Seattle Design Commission

APPROVED MINUTES OF THE MEETING 6 January 2005

Projects Reviewed

Phase I Site Development - Schematic Design

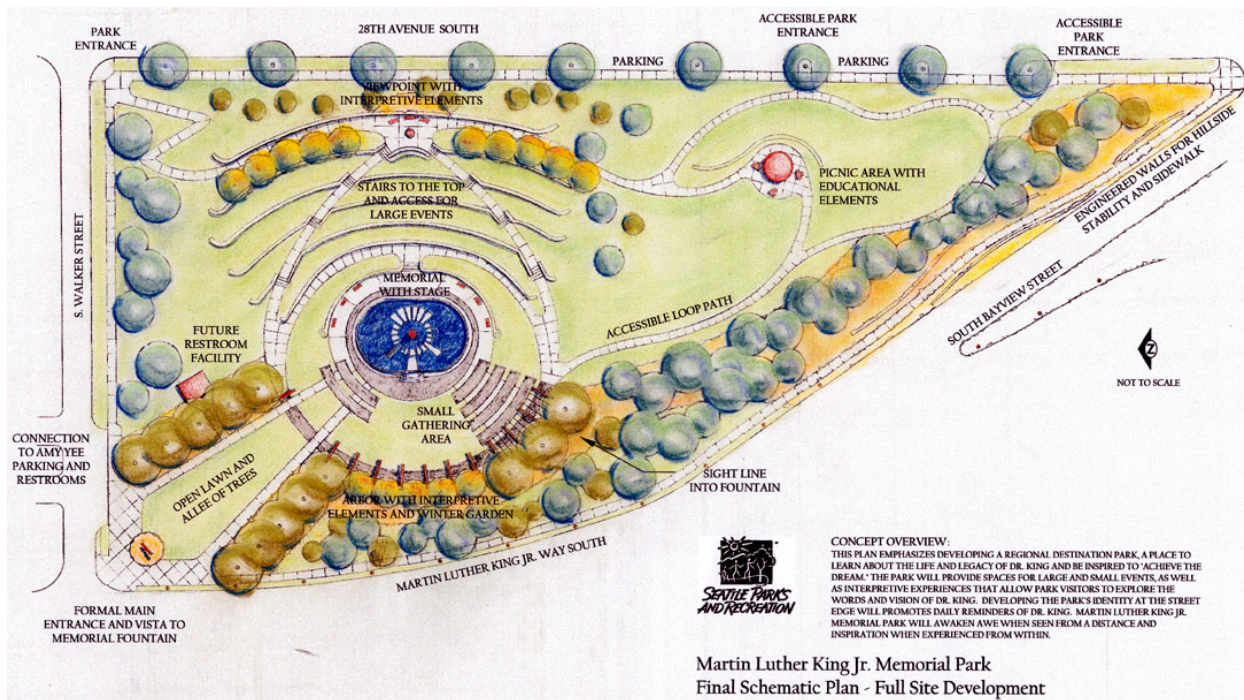
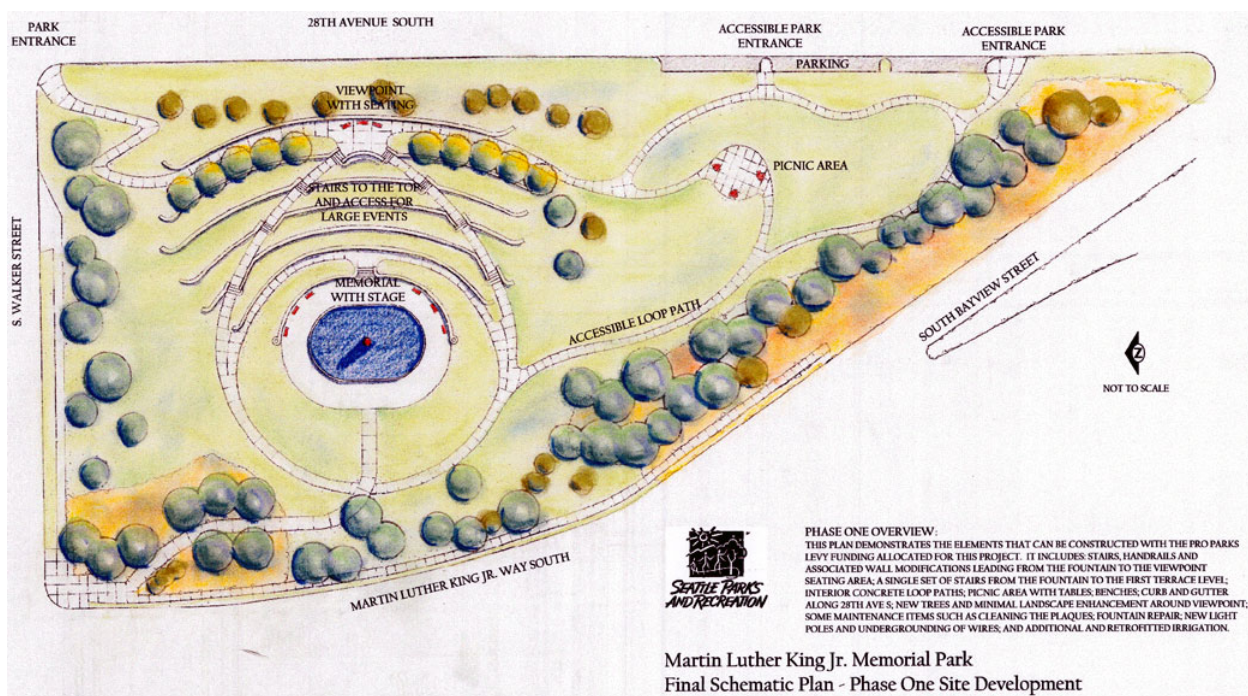
- appreciates how proponents made the most of the good qualities of the park; the overlook, the stairs and the picnic area.
- generally questions the location of the fountain and the sculpture; that perhaps they are not located in the right place, and they interfere with the function of the amphitheater as an event space.

- suggests the use of plantings to better define the amphitheater space but also maintain visual access into the park.
- suggests that Phase I include improving visual access into the park, especially in its northwest corner, encouraging that the regrade and planting proposed for the northwest entrance be included in the Phase I plan.

- Suggests changing fountain to stage space by either moving fountain or bridging over it.
- Expresses concern about holding on to an unsuccessful element and trying to improve it, suggesting that it is not good in the long run.

- Suggests moving fountain at a later time when the budget allows it, and focusing on other efforts at this time.
- Suggests installing a temporary stage on top of fountain that can allow amphitheater function.

- Expresses concern with using expensive materials, specifically granite, due to budget constraints.
- Cautions screening MLK, Jr. sculpture too much with plantings; restricting necessary visibility.

- Reminds proponents not to install plantings in areas that will be changed in later phases.
- Encourages installing planting plan proposed in master plan during Phase I, even if pathways can not be installed at that time, the trees will create structure and visual corridor.

- Suggests that parking on the east side of the park be moved closer to the overlook to increase accessibility to the memorial.
- Proponents replied that they made a conscious effort to remove parking from the memorial experience, so provided nine parallel parking spaces on the south east end of the street.

- Encourages parking along the full length of the street; does not believe that it will interfere with experience due to the existing grade change and suggests that parallel parked cars will help provide a buffer from street traffic.

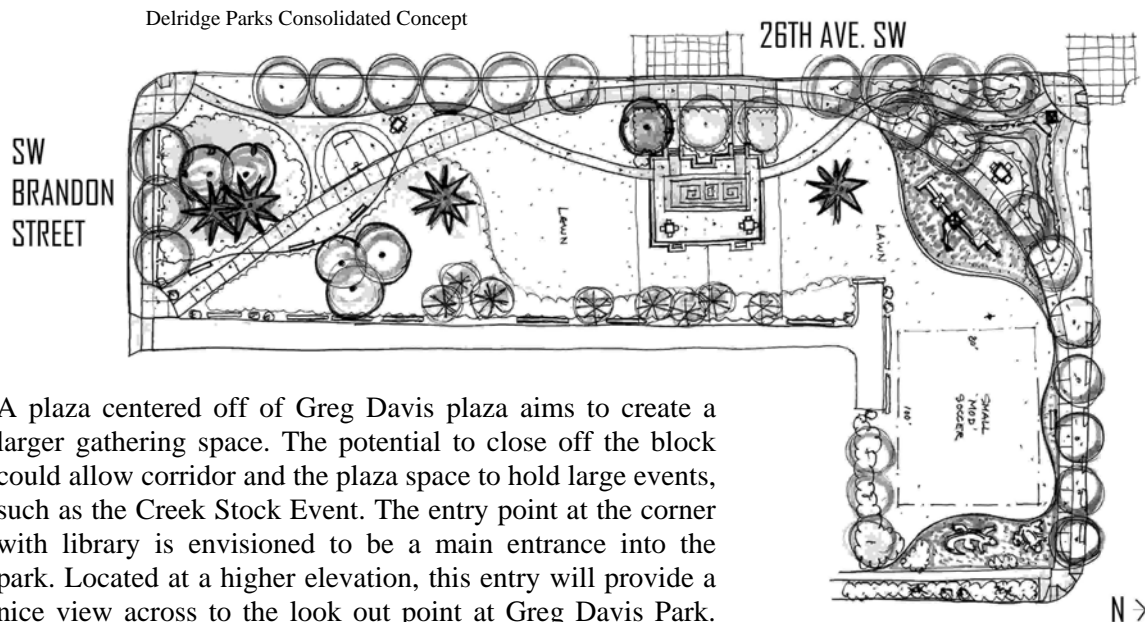
- Suggests that there is no cohesive whole of the design; that it instead looks like isolated elements strung along.
- Suggests that the proponents' attempt to incorporate all of the disparate elements expressed during the community meetings weakens the design overall.

- Recommends that the proponents develop a cohesive, clear design.
- Suggests that proponents need to strengthen the connection to Greg Davis Park.
- Suggests changing parking from the p-patch to 25th/26th street, if possible.

- Suggests that proponents establish a street edge with sidewalks and curbs on all four sides to provide definition between the park and the road and to provide connections to and around the park.

- Suggests that spaces seem discontinuous and perhaps the arc concept could be a series of spaces rather than the sidewalk that connects them.
- Believes that the P – Patch creates a blockage in its current location. Recognizes that community wants P – Patch to remain in its current location but encourages proponents to be an advocate for the greater space.

- Argues that the arc looks good in plan but that no one will walk it as proposed; the arc might be a good armature to organize the program but needs to be enforced.

Off Leash Area – schematic design and cross sections 3 and 4

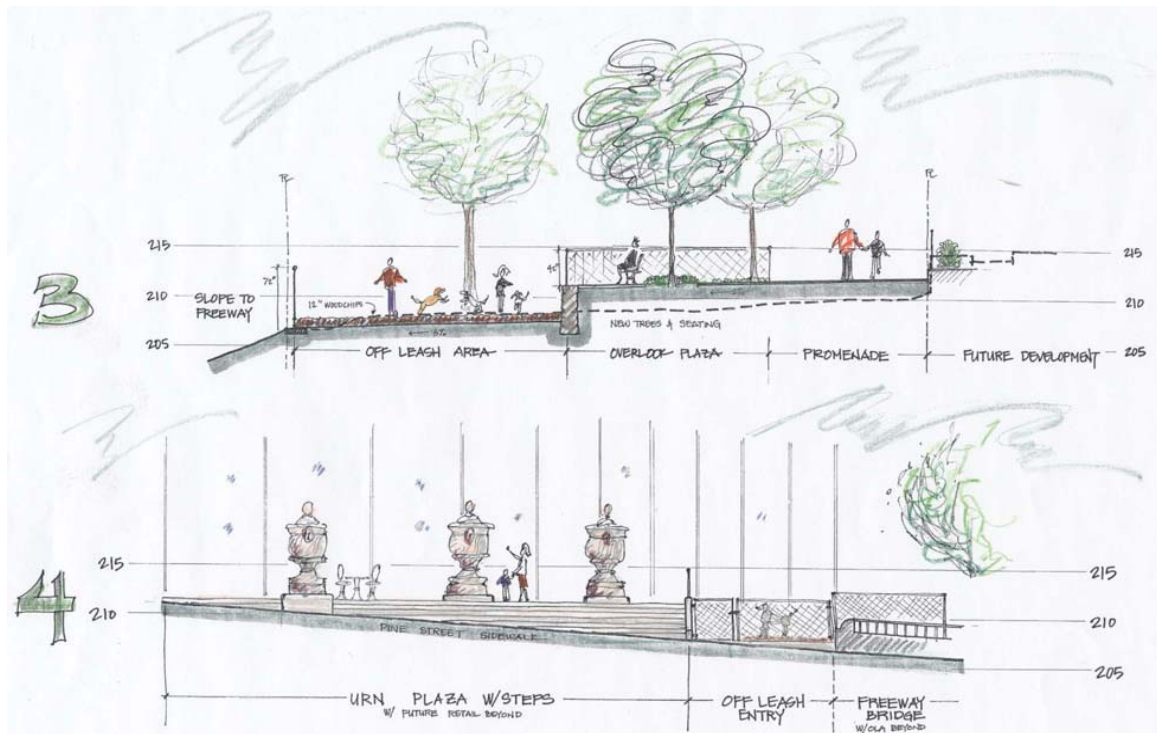
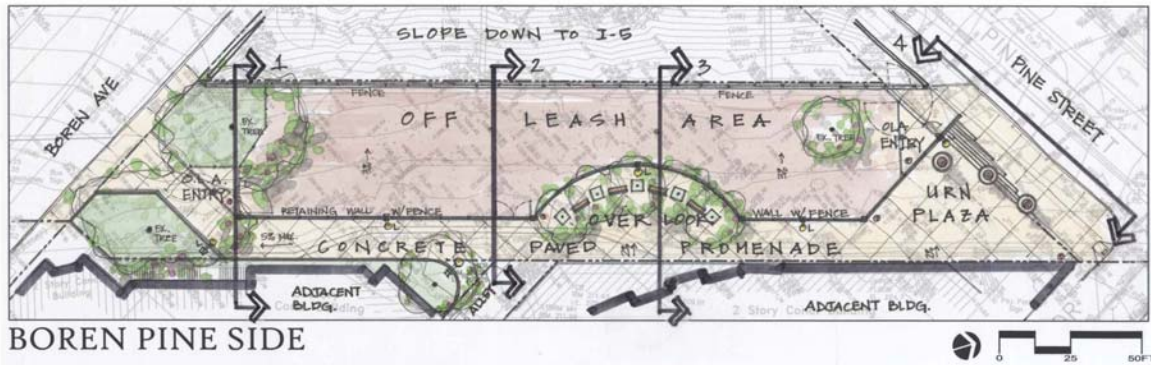
- **endorses the urban off leash area.**
- **suggests pushing the urban feel of the park and creating an interesting entrance.**
- **suggests using fence material other than chain link fencing unless it is used creatively. recommends that the planters be removed from the column staircase to promote a simpler space.**

- **suggests that Pine St. entry to the off-leash area be pulled off of the street, but recognize that there may be some grading issues in order to do so. In response to the notion of creating commercial activity in the park, the Commission agrees that the presence of tables and chairs in Urn Plaza will just provide this kind of space, and will encourage neighbors and passersby to use the space.**

- Yes, there will be a fence above the vertical retaining wall.
- Asks if it will be a chain link fence
 - Yes, but black, small and discreet
- Suggests the use of a nice fence since it is one of the only design elements of the park.

- Funding restraints may restrict us from using a nicer material.
- Encourages pushing an urban “feel” to the park.
- Suggests moving the fence line to align with the column park side making the two areas feel like one park

- Suggest removing the planters from the stairway below the columns to strengthen and simplify the space.
- Suggests celebrating one entry as the main entry but maintaining the two entries for safety reasons.

- Suggests the use of a more substantial urban guard rail rather than a chain link fence between the promenade and the off leash area.
- Suggests making a stronger urban gesture to better match the urban environment off of Boren Street.

- Suggests using a nicer material for the fence at least in the overlook area if it is unaffordable to use for the entire fence length.
- Asks if entrance could be located off of plaza rather than Pine St. to allow more breathing space

- The entrance is located off of the sidewalk at Pine St. because at that location it is at grade.
- Suggests using a curve rather than a geometric form for outlook area to compliment this form used throughout the park.
